File RZP-1996-045

Name: Fall Valley Subdivision – 25 ½ Road and F ½ Road

REVIEW COMMENTS AND
PETITIONER'S RESPONSE

FILE: #RZP-96-045
DATE: March 15, 1996
STAFF: Michael T. Drollinger
REQUEST: Rezone/Preliminary Plan - Fall Valley Subdivision
LOCATION: SE Corner 25 1/2 Road & F 1/2 Road
ZONING: PR-9.6

FALL VALLEY PRELIMINARY PLAN

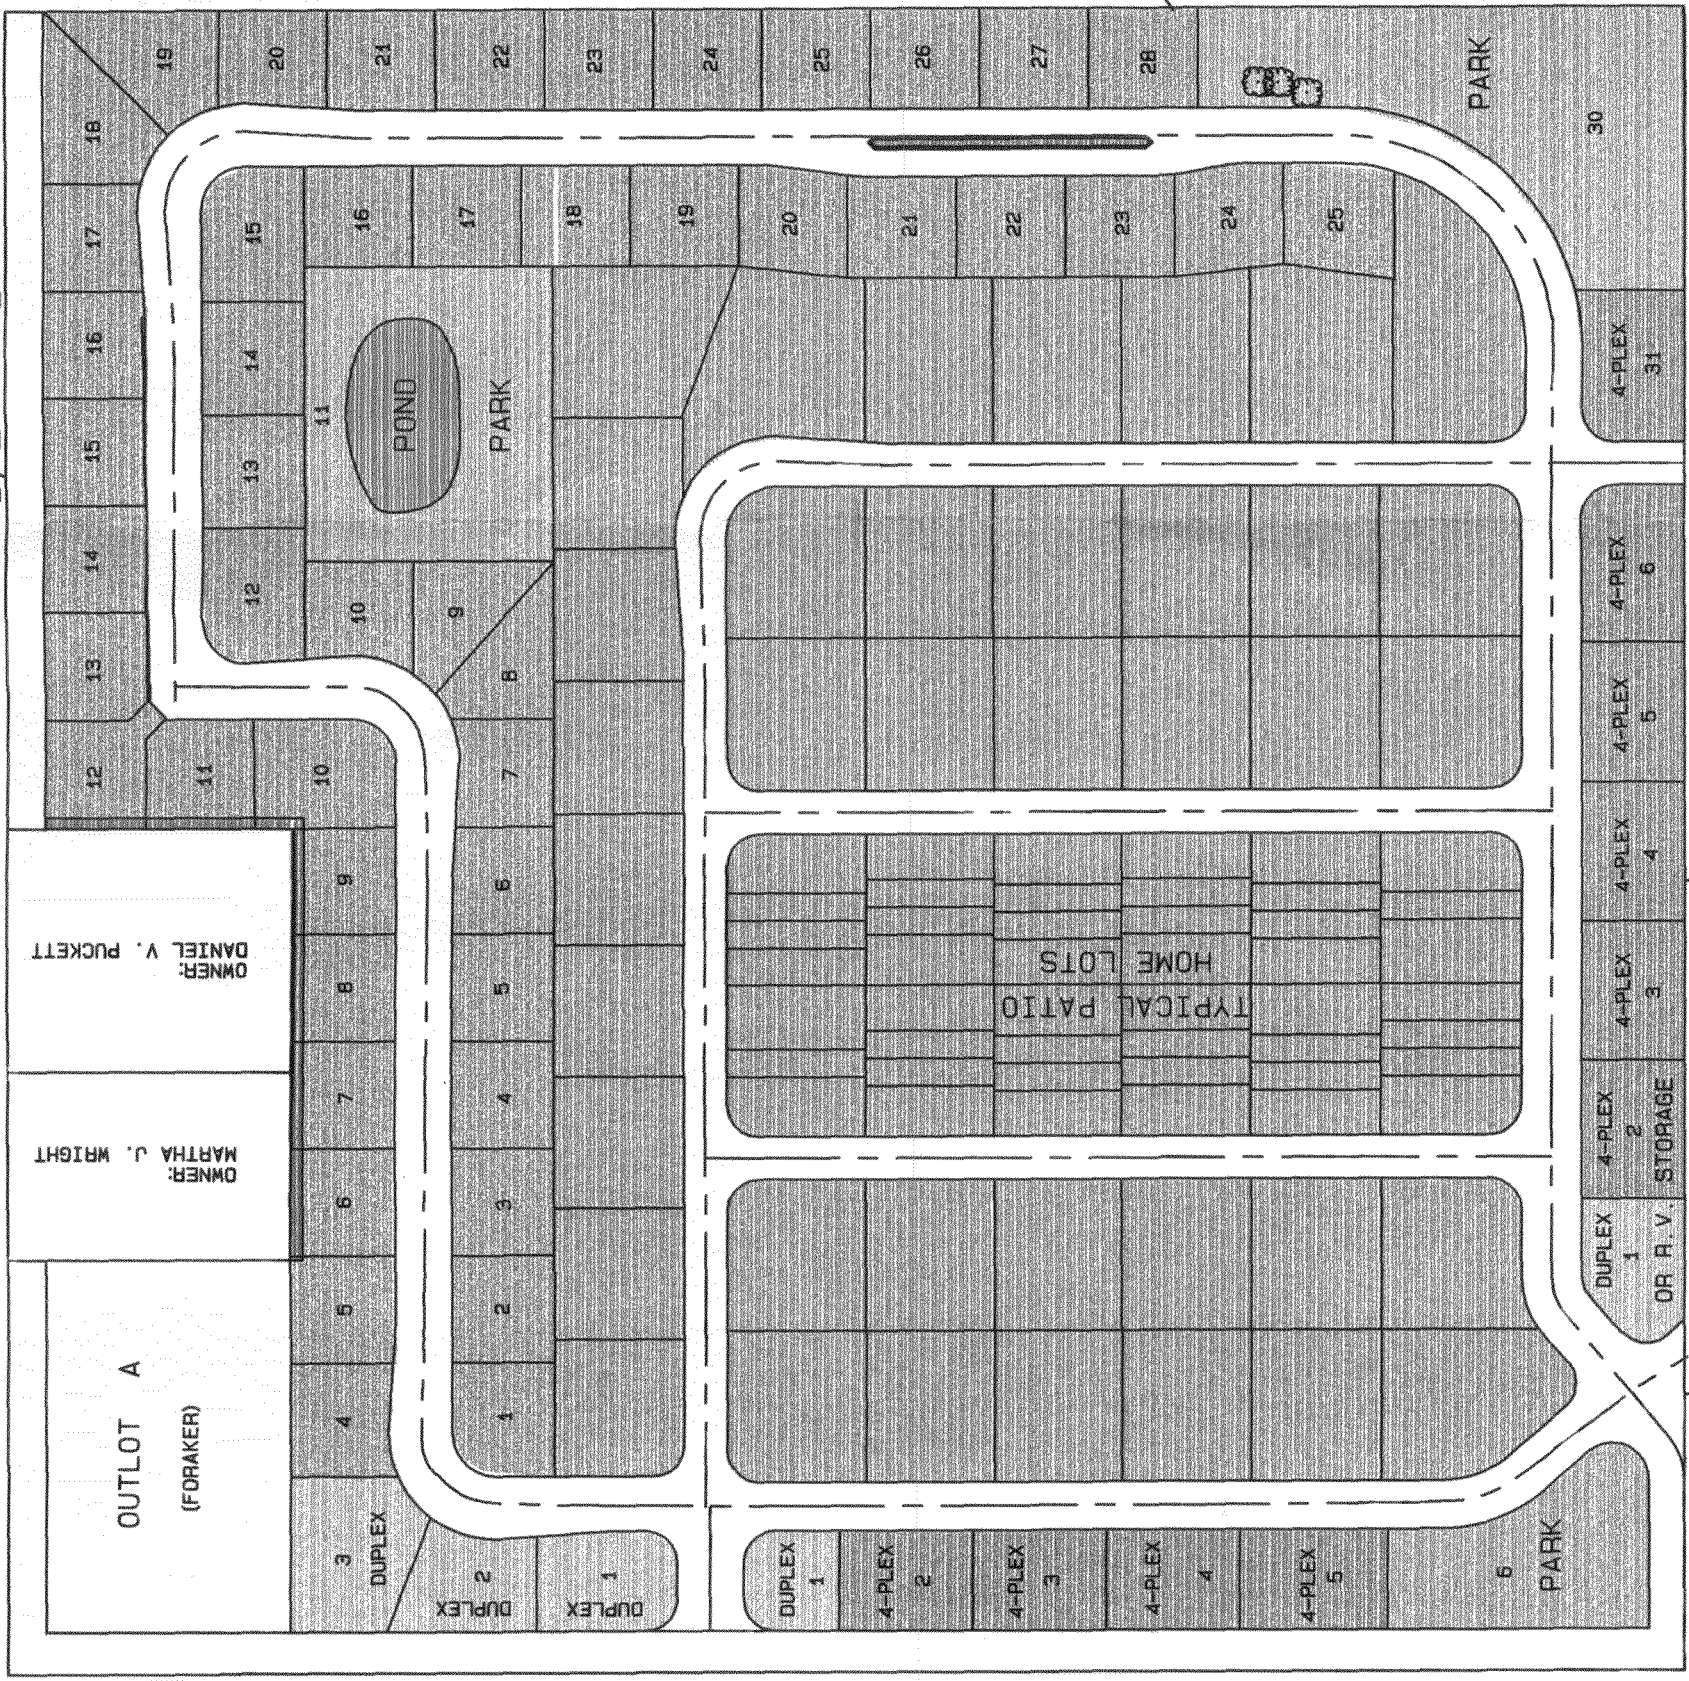
1. Insufficient detail for Preliminary Plan.
2. Double fronting lots along 25.5 Road are undesirable.
3. A landscaped berm or combination of fencing and landscaping should be provided along 25.5 Road frontage to mitigate traffic noise and improve the street scape.

1. The materials submitted present inconsistent details regarding the submittal - the general project report, drainage report and the plans submitted contain conflicting information. **Please resolve these discrepancies as a complete review of the proposal will take place only after the information submitted is consistent.**

2. Please provide the following information on the Preliminary Plan:
 - a. Size of proposed lots
 - b. Typical site plan (layout) of duplex and fourplex lots

- c. Please clearly identify duplex and fourplex lots on the plan
 - d. Proposed street sections must be identified on the plans
 - e. Locations of multifamily buildings not identified on the plans

4. The design should accommodate pedestrian/bicycle access between the development and F 1/2 Road to facilitate access by non-vehicular traffic.
5. Please correct errors in surrounding zoning information on Preliminary Plan.

Response: See revised Preliminary Plan.

Response: 1. See revised General Project Report, Preliminary Plan, Preliminary Drainage Plan, and Traffic Study.
2. See revised Preliminary Plan and typical site plans.
3. See revised Preliminary Plan.
4. See revised Preliminary Plan.
5. See revised Preliminary Plan.
6. See revised Preliminary Plan.

FALL VALLEY TYPICAL 4-PLEX 4 UNIT DETAIL

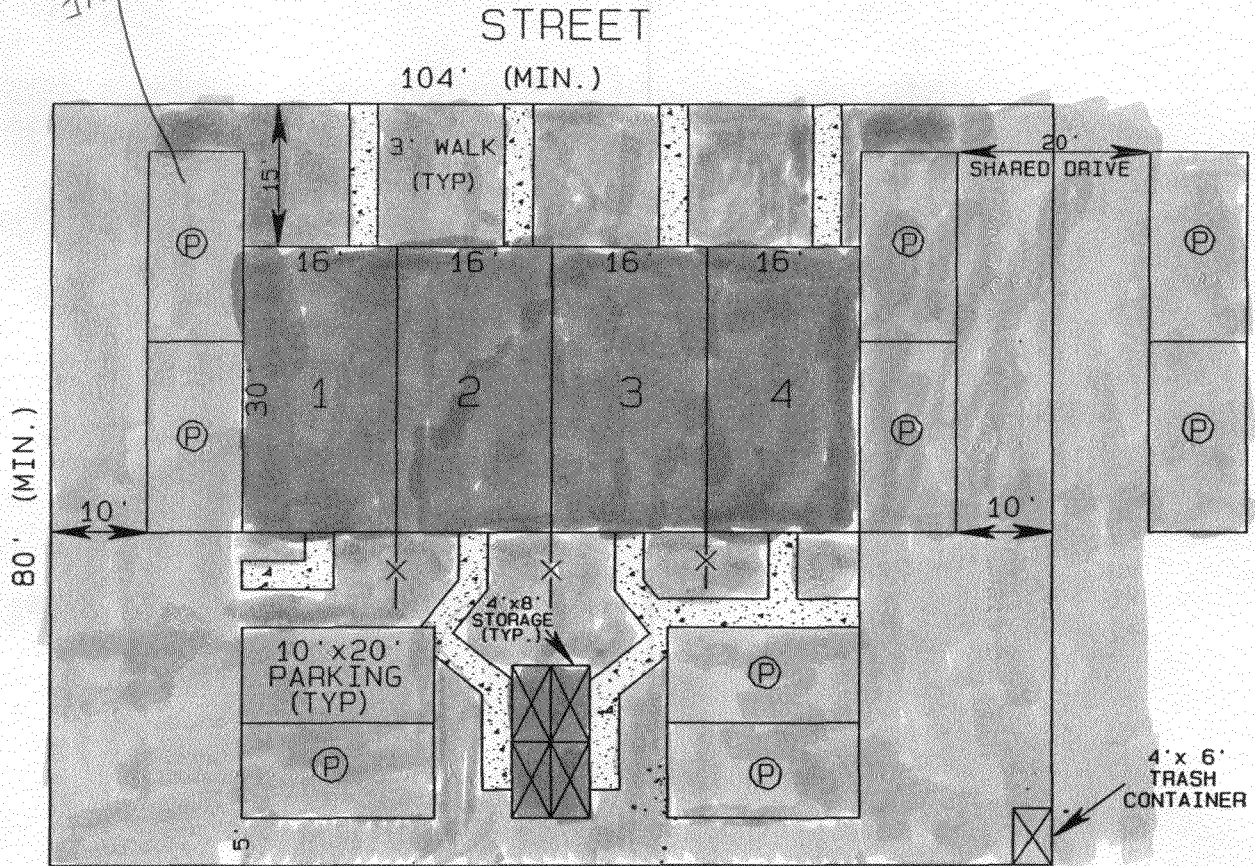
*No PARKING
IMPLY setback*

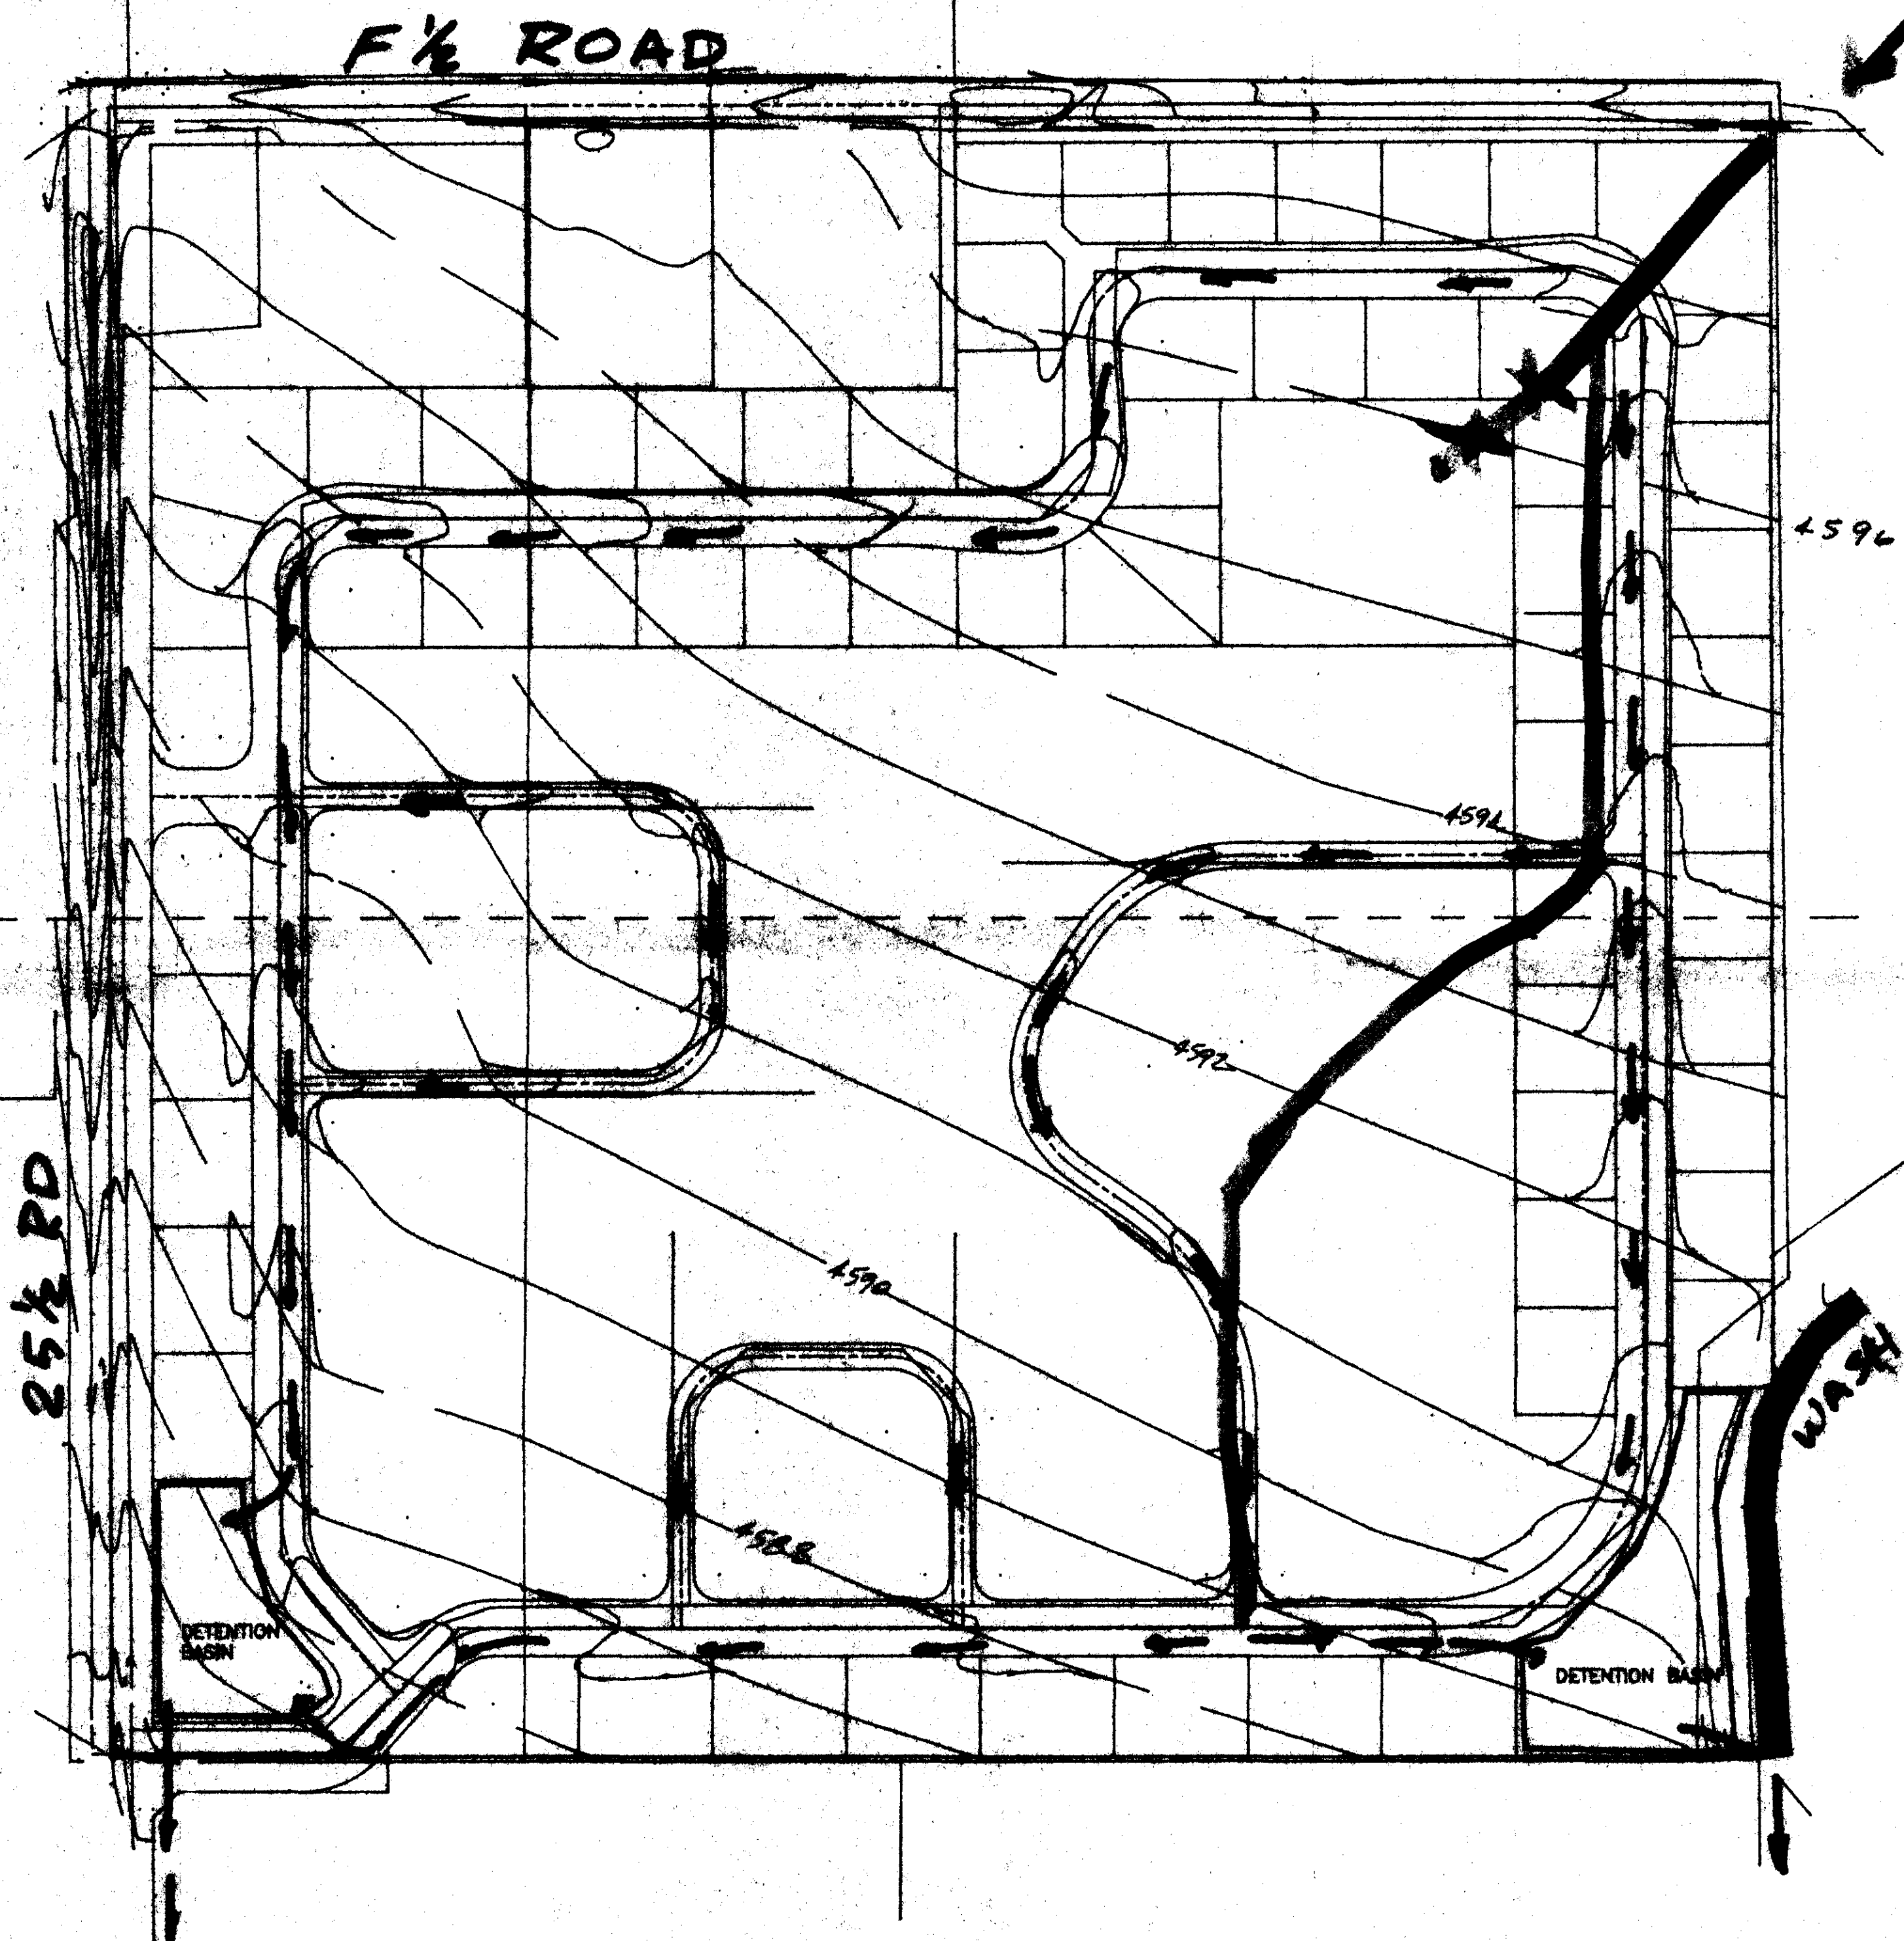
basin
break?
